Docket Item #3
BAR CASE # 2018-00271

BAR Meeting
July 25, 2018

ISSUE: Certificate of Appropriateness for Alterations, Signage and Waiver of Rooftop Screening

LOCATION: 116 King Street

- x1 24" x 24" Double Sided Polymetal Blade sign- 4 sq ft
- x1 70" x 77" Painted logo On brick - 37.5 sq ft
- x1 21.5" x 74.5" Painted logo On brick - 11 sq ft

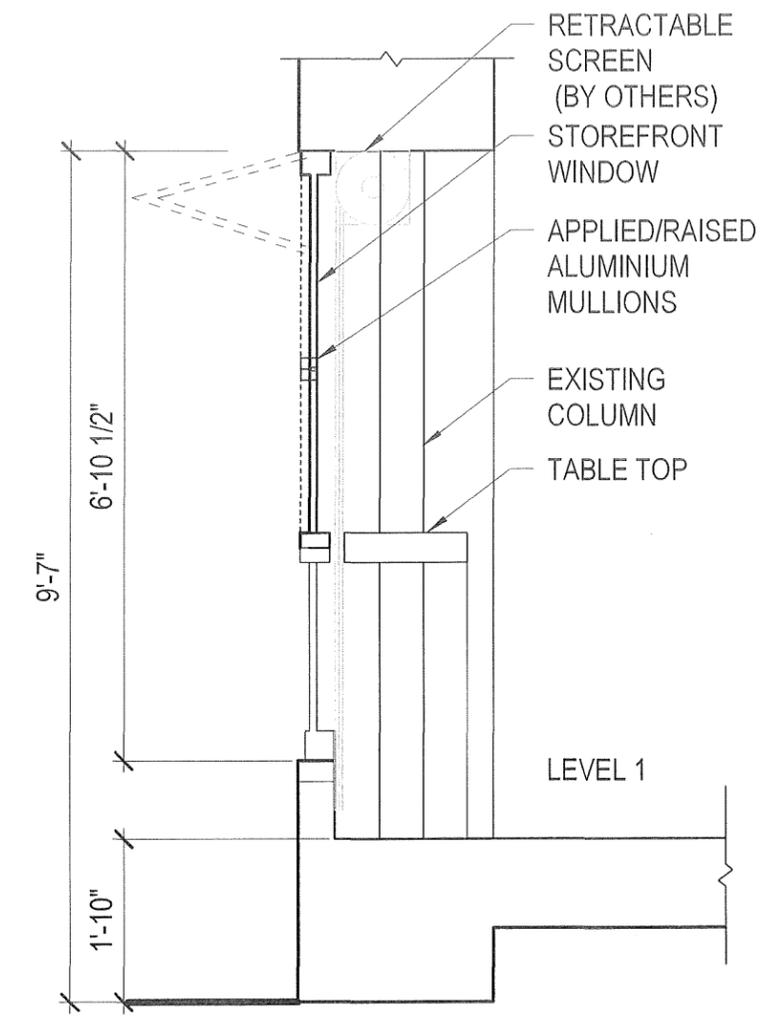
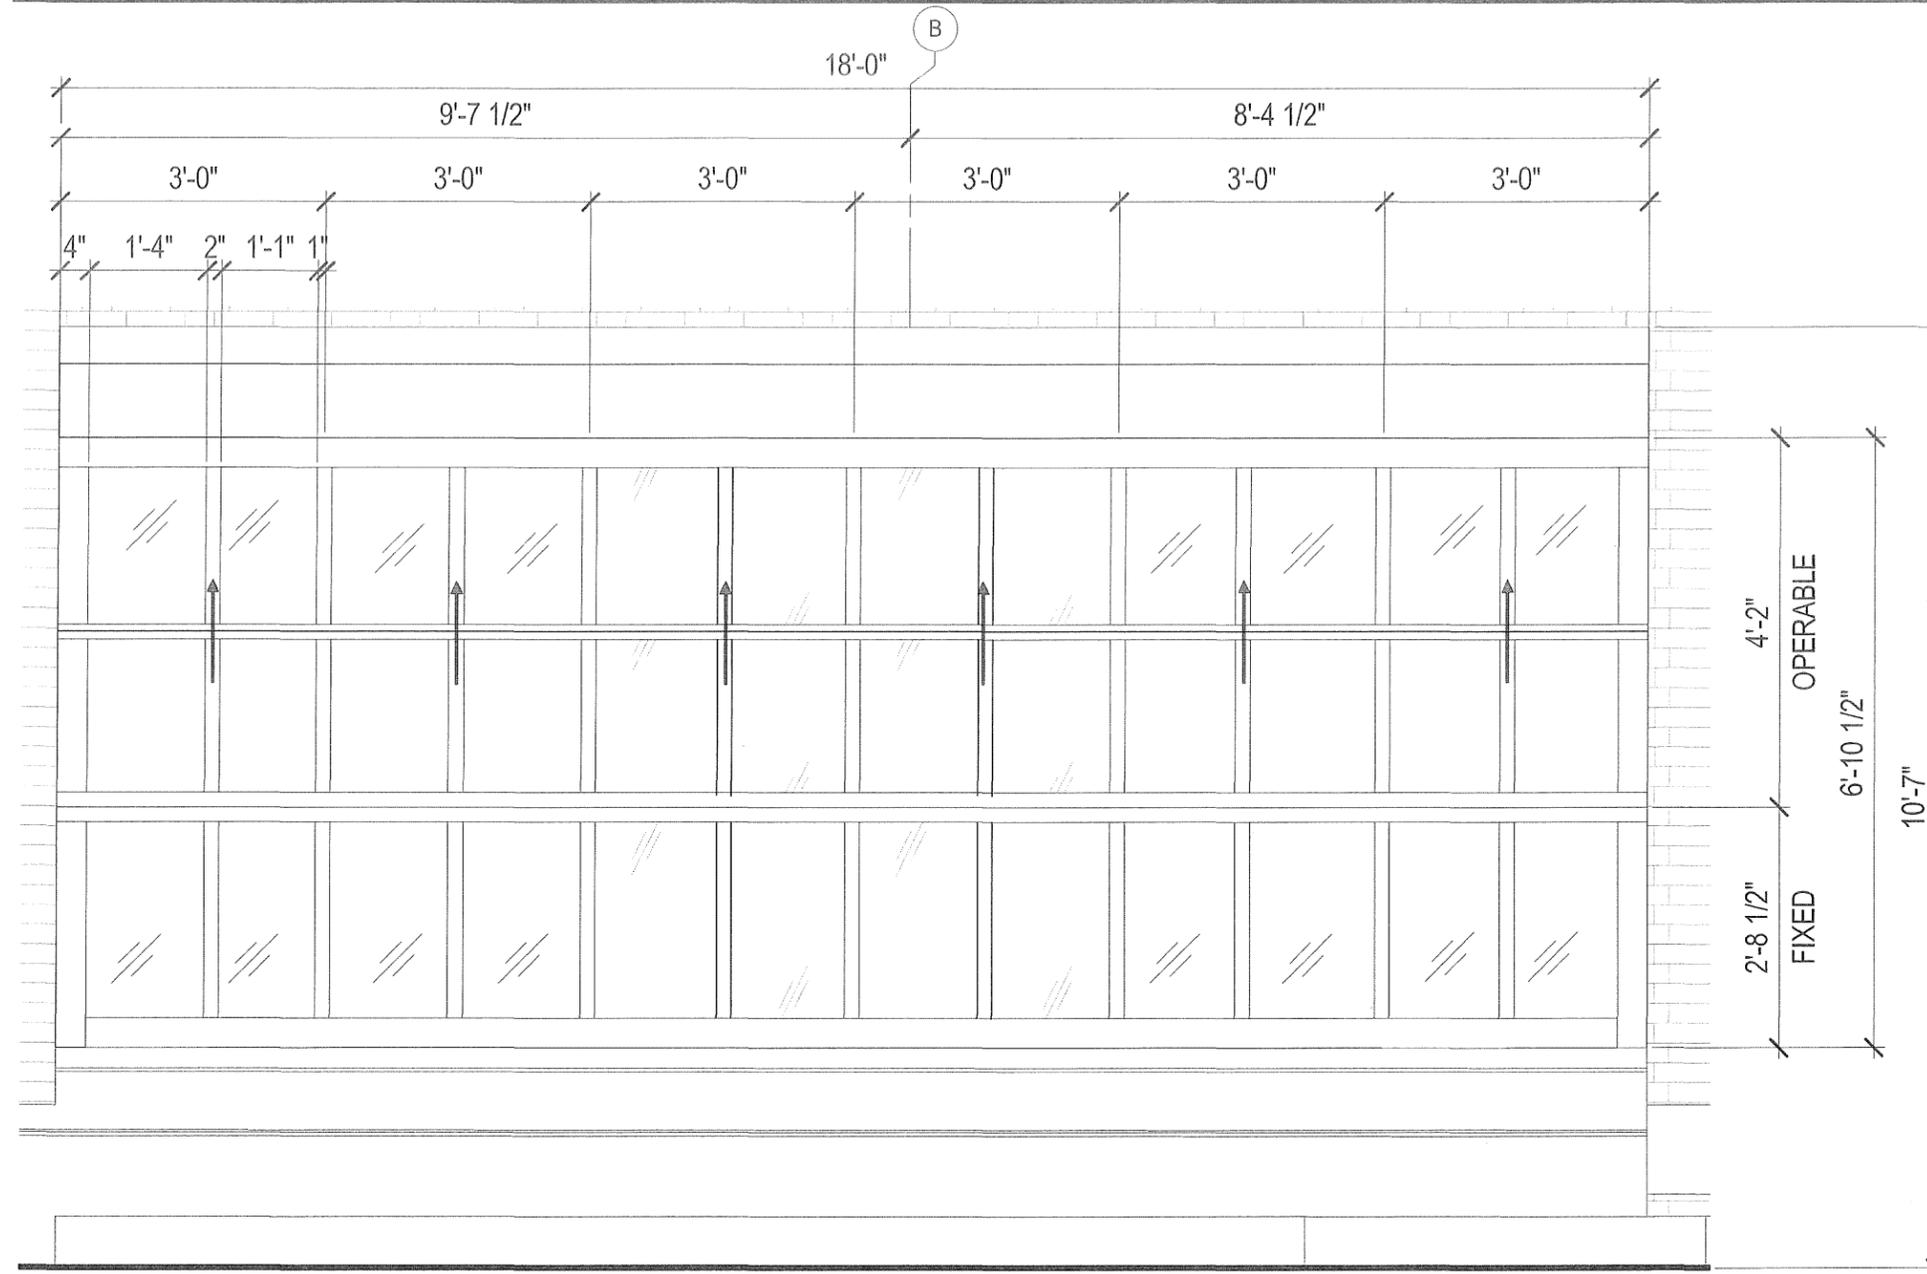
1. Delete the painted wall sign above the storefront window; and,
2. Reduce the sign area of the proposed design for the two remaining signs to comply with zoning requirements, working in consultation with staff.
3. The color of the LED sign lighting may be no whiter in color than 4100 Kelvin.

Staff commends the applicant for proposing painted signs on the masonry building. Not only is there historic precedent for painted signs in the historic district, but they are easily removed, and their installation does not damage historic masonry on already painted buildings. Although the historic building is now part of a larger parcel, as noted above, for sign calculation purposes it is considered a separate building and the maximum amount of signage is determined by the width of 116 King Street, or 34.33 square feet. The proposed signs exceed that maximum allowable square footage and staff recommends that the center sign be removed. Except for O'Connell's restaurant at 112 King, signage on the nearby buildings in this block of King Street is largely limited to two signs per business. Even with the removal of the center sign, the amount of proposed signage exceeds the zoning ordinance sign area for business throughout the City. Staff believes that the design of the proposed painted wall sign could be slightly reduced overall to meet the requirement, but when the take-out service is available the applicant will likely install a third sign, at least on a temporary basis, so the applicant should consider retaining some sign area for the take-out sign.

G PROPOSED/EXISTING ROOF MECHANICAL PLAN
SCALE: 1/4" = 1'

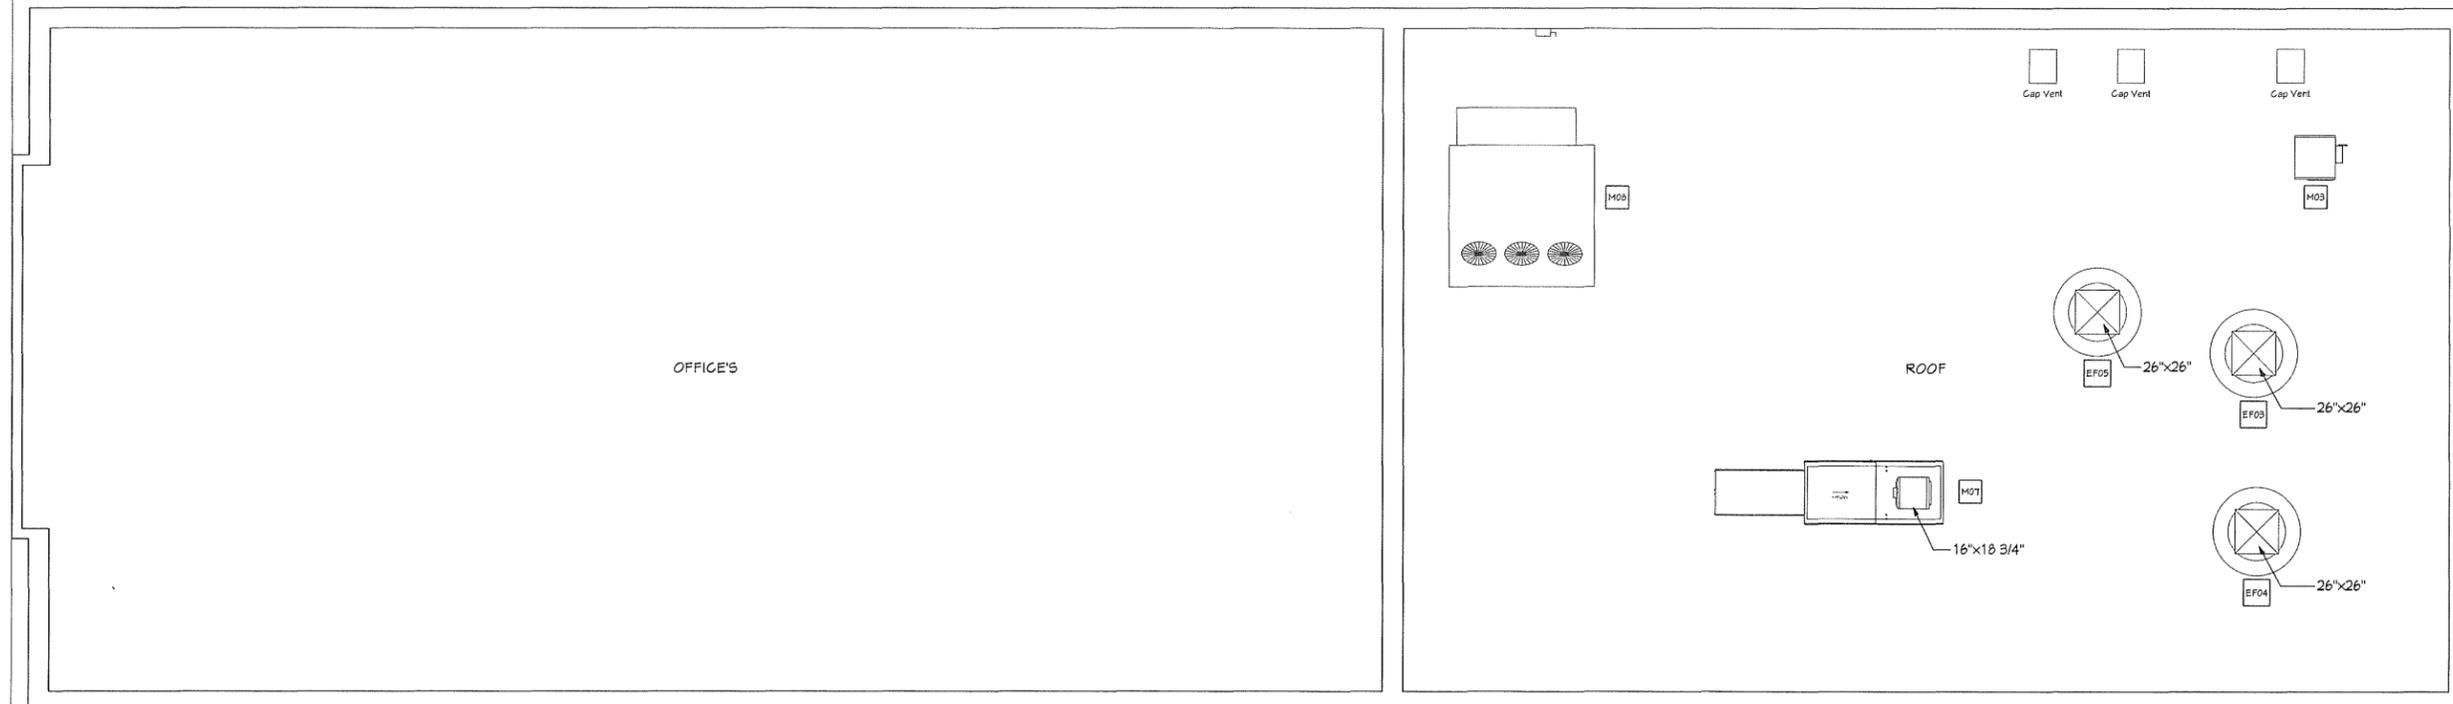
The zoning ordinance requires that all rooftop mechanical equipment throughout the city be concealed or screened, however it does not clearly define where the HVAC units must be screened from. Section 6-403(B)(3) of the zoning ordinance permits the BAR to waive the screening requirement for rooftop mechanical equipment, should the BAR find that the screening would be more visually obtrusive than the units themselves, or if the screening would damage a historic structure. As the BAR's purview is limited to what may be seen from a public way, the BAR has, generally, considered the units to be functionally concealed if they were not visible from a pedestrian standing on the sidewalk across the street, though in some cases views from neighbor's upper floors has also been considered when a waiver of screening was being requested. Although the rear alley is public, the mechanical equipment will not be visible from either the alley or surrounding rights-of-way.
